# Access Compliance Report

## Public Rights-of-Way

### (Curb Ramps)

Intersection ID: 47442	Main Street: OROFINO_CT	Cross Street: KALISPELL_LN	Location: SW
ADA ID: 7F525907535D	Ramp Type: PerpDiag	Initial Pass/Fail: Fail	Overall Compliance: No
Severity Score: 13.75			
Codes/Mitigation Info/Possible Solution		Field Measurements/Component Compliance

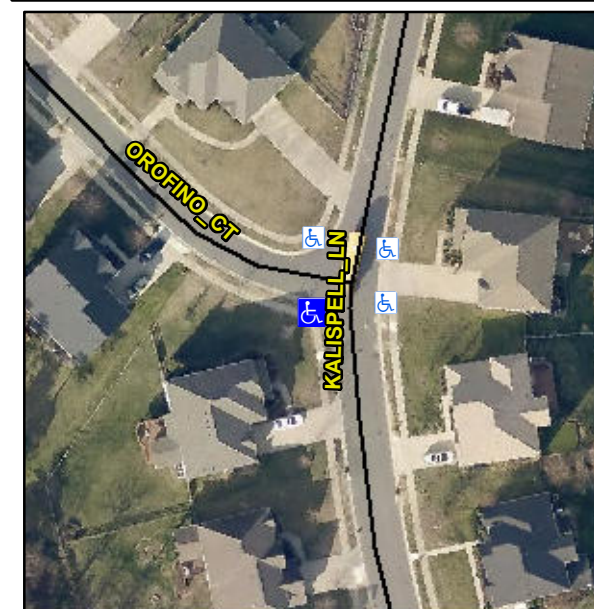
**Not Found, R304.2.2, R304.5.3**

Compliance	Description	Data	Compliance	Description	Data
N/A	Ramp Length (in)	47.0	No	Ramp Slope (%)	9.2
Yes	Ramp Width (in)	48.0	No	Ramp XSlope (%)	4.8
N/A	Flare Type LT	N/A	N/A	Flare Type RT	N/A
N/A	Flare Slope LT (%)	N/A	N/A	Flare Slope RT (%)	N/A
N/A	Flare Traversable LT?	N/A	N/A	Flare Traversable RT?	N/A
N/A	Landing Length (in)	N/A	N/A	DWS Provided?	N/A
N/A	Landing Width (in)	N/A	N/A	DWS Contrast?	N/A
N/A	Landing Slope (%)	N/A	N/A	DWS Length (in)	N/A
N/A	Landing X Slope (%)	N/A	N/A	DWS Full Width?	N/A
N/A	Landing Curb? (Y/N)	N/A	N/A	DWS Offset (in)	N/A
N/A	Shared Landing?	N/A			
N/A	Gutter Ponding?	N/A	N/A	Gutter Slope (%)	N/A
N/A	Gutter Lip Ht (in)	N/A	N/A	Gutter X Slope (%)	N/A
N/A	Painted X Walk1?	No	N/A	Painted X Walk2?	No
	X Walk 1 Direction	To E		X Walk 2 Direction	To N
N/A	X Walk 1 Width (in)	N/A	N/A	X Walk 2 Width (in)	N/A
	X Walk 1 Slope (%)	1.1		X Walk 2 Slope (%)	4.5
	X Walk 1 X Slope (%)	7.6		X Walk 2 X Slope (%)	2.0

**Remove & Replace Curb Ramp With Two New Directional Ramps or Equivalent.**
